## Addendum #01

**Services Requested: Asphalt Maintenance Project + Concrete Work**

**Property Location: Northgate Plaza, 2230 North Reserve St., Missoula, MT 59808**

CONCEPTUAL PARKING LAYOUT

**11. Add Parking Spaces (back lot behind 100 suites)**

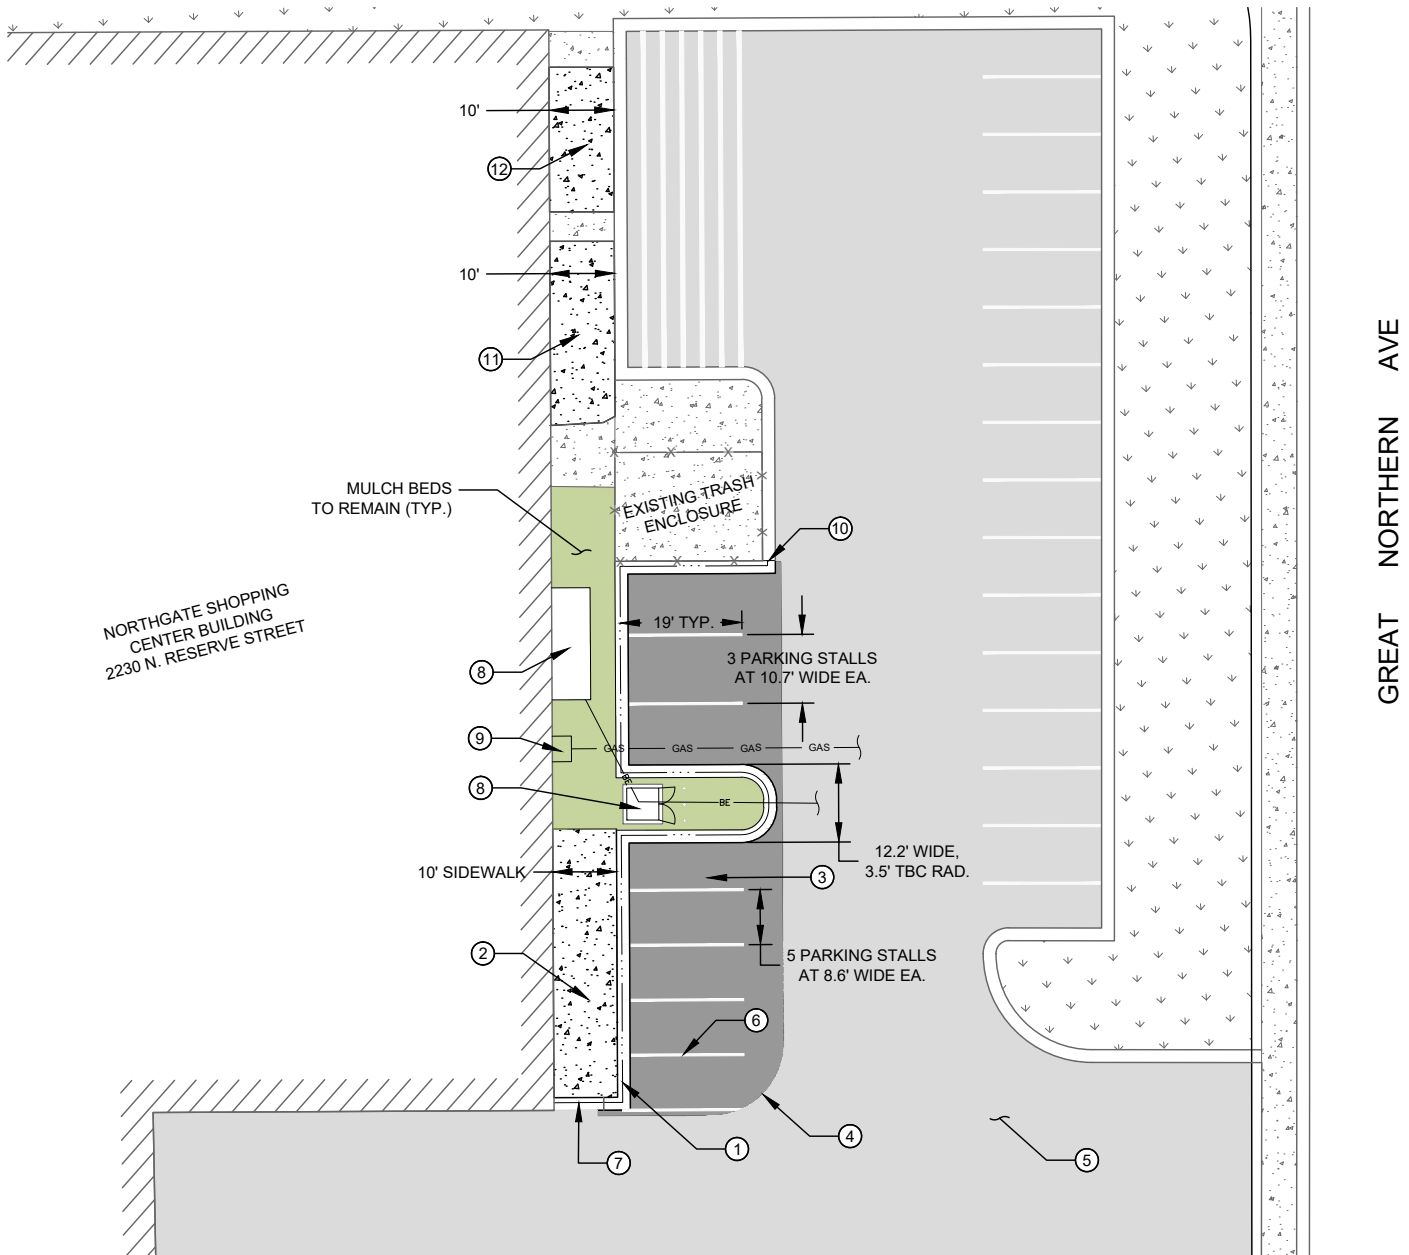
- Contractor shall remove the existing curbing and landscaping to create new walking and parking spaces.
- Include all labor, materials, trucking, and equipment to demolish, remove, compact base, form and finish concrete and asphalt and paint new parking spaces and hash marks.
- See attached Exhibit C.
